CALL NO. 206
CONTRACT ID NO. 121354
Addendum # 3

Subject: MARSHALL-TRIGG Counties, 121GR12D054-BRO
Letting November 16, 2012

- (1) Revised - Special Note For deep soil Mixing - Pages 20-36(b) of 177
- (2) Revised - Special Note for Pile testing - Page 96(b) of 177

SPECIAL NOTE FOR WET DEEP SOIL MIXING US 68 / KY 80 OVER KENTUCKY LAKE

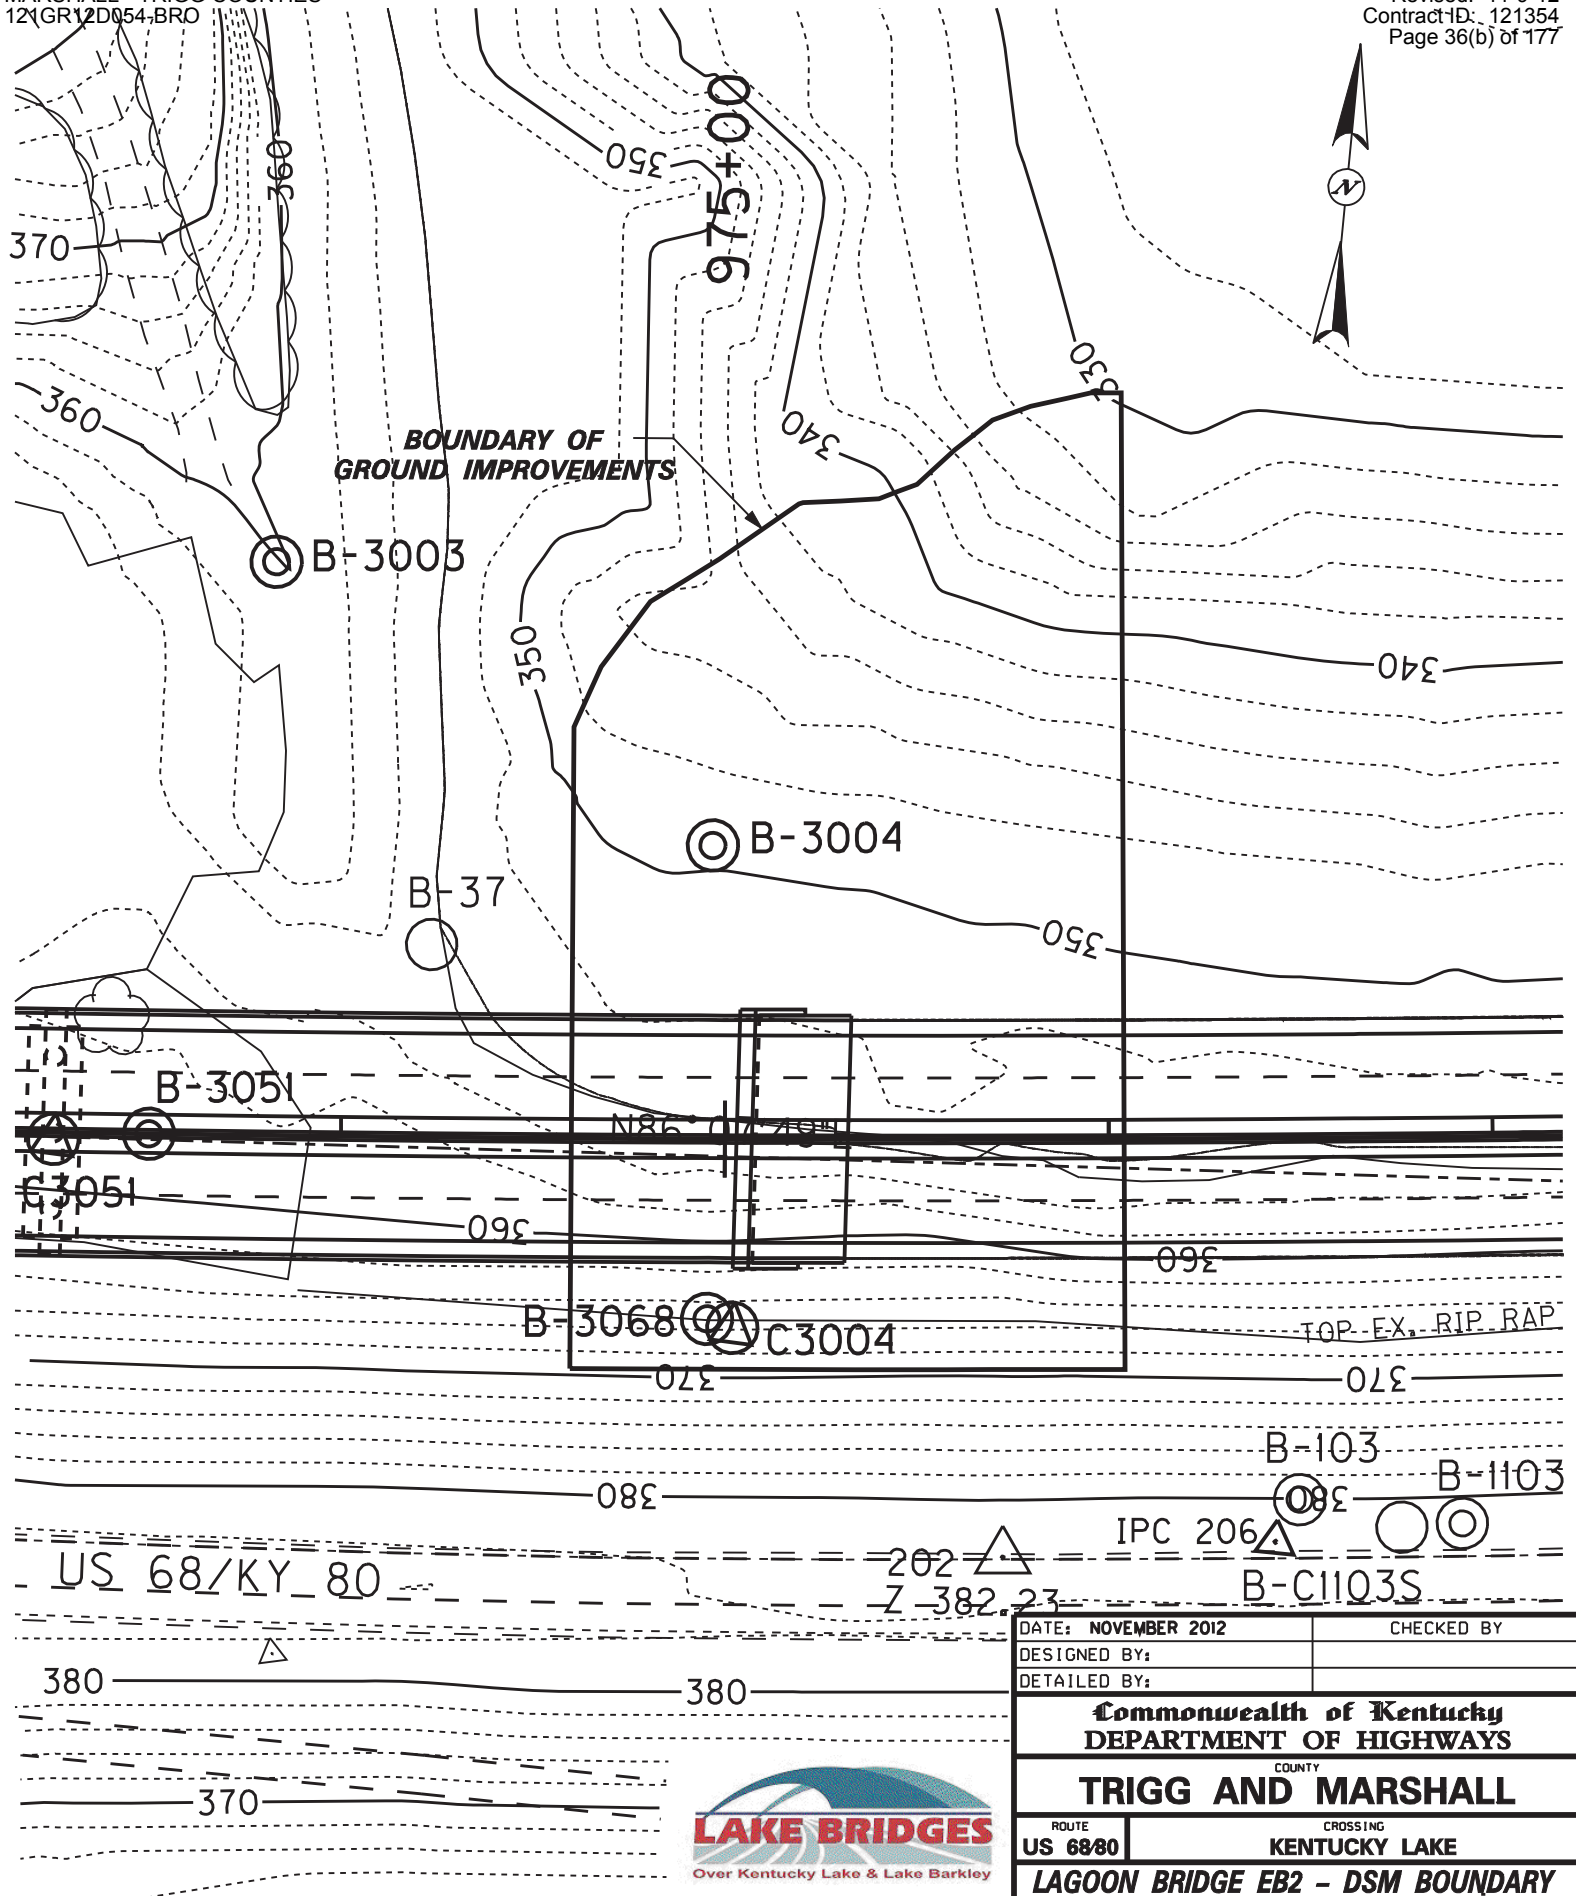
An exclusionary zone where pile foundations are to be constructed at Lagoon Bridge End Bent 2 will also be utilized. See the plans for more information on the location of this exclusionary zone. The Contractor will not be permitted to install DSM columns through permanent Granular Embankment. To construct the DSM columns in water, the Contractor can use a barge and/or construct a temporary earthen/aggregate platform within the proposed causeway footprint. This temporary platform will be designed and constructed at the Contractor's own risk and at no additional cost to the Department. This temporary working platform, if chosen, will need to remain within the proposed permanent embankment for permitting requirements. However, if the Contractor obtains any necessary permits for this temporary platform to extend outside of the permanent footprint and meets all applicable requirements, then it will be acceptable to the Department for the Contractor to construct the temporary working platform outside the limits of the proposed permanent embankment. These temporary platforms will have to be removed prior to placing the Granular Embankment up to Elevation 363' as detailed in the project plans. Also, all DSM columns shall begin with the top at the existing ground surface and not at the top of the temporary working platform. All costs associated with installing and removing the temporary work platform are incidental to the bid price for "Wet Soil Mixing" (CY). The Contractor shall submit plans for the temporary earthen/aggregate platform for review by the Department. Refer to Section 2.0 of this special note for the time allotted for the plans review by the Department.
